SB-GA8-2009-58

Issue 2

Service Bulletin

Repair to Tailcone Side Skin

Figure 1

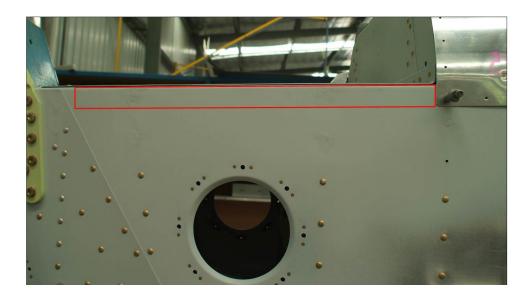
- 1. Remove fin and horizontal stabiliser in accordance with Section 55-30-00 and 55-10-00 of the GA8 Service Manual respectively.
- 2. Remove Wear Strip, location is shown in red on Figure 1.

Figure 2

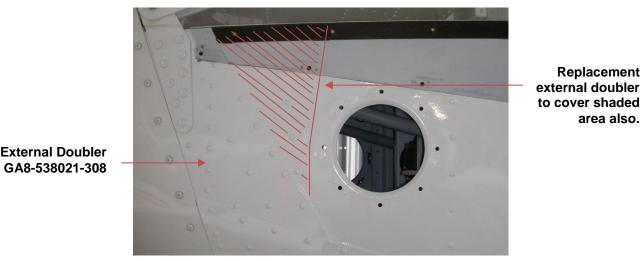
- 8. Remove and use as a template the external doubler (P/N GA8-538021-308), manufacture a new external doubler for the right hand side as shown in Figure 2. Material is to be 2024-T3 Alclad sheet per QQ-A-250/5, 0.040" thick. When removing the doubler, note type of fasteners (MS20470AD/MS20426AD), as the same type are to be use to install the replacement doubler in Step 11. Ensure that the deformed skin in the tailcone is encapsulated (at least rivet row beyond) by this replacement doubler. Ensure a smooth radius for the contour around the inspection hole.

This external doubler replaces existing part GA8-538021-308 remove and use as template.

Figure 4

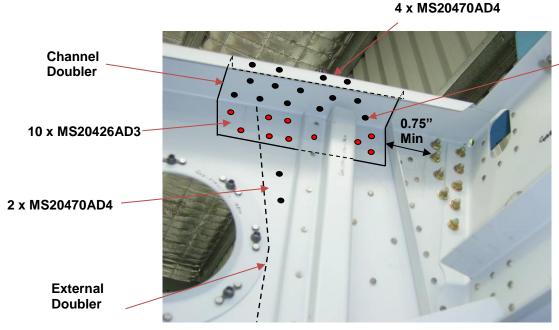
11. Prepare a doubler channel approximately 10 inches long from 0.025" thick 2024-T3 Alclad sheet per QQ-A-250/5 as shown in Figure 4.

- 14. Place channel doubler between the tailcone skin and the Aft Inspection Hole Stiffener, as shown in Figure 4. Place the external doubler in position. Install external doubler using fasteners with same type as existing (MS20470AD and MS20426AD rivets). Install channel doubler using additional MS20470AD4 and MS20426AD3 rivets as shown in Figure 4. Install Aft Inspection Hole Stiffener in remaining holes using same fasteners as were removed. Ensure 2D edge distance is maintained on all rivets, minimum 4D spacing between rivet, and the aft edge of the channel is at least 0.75" forward of the rear pickup bolts. (To prevent the skin cracking at the bolt head).

10 x MS20470AD4 installed through doubler, channel and top deck (not shown)
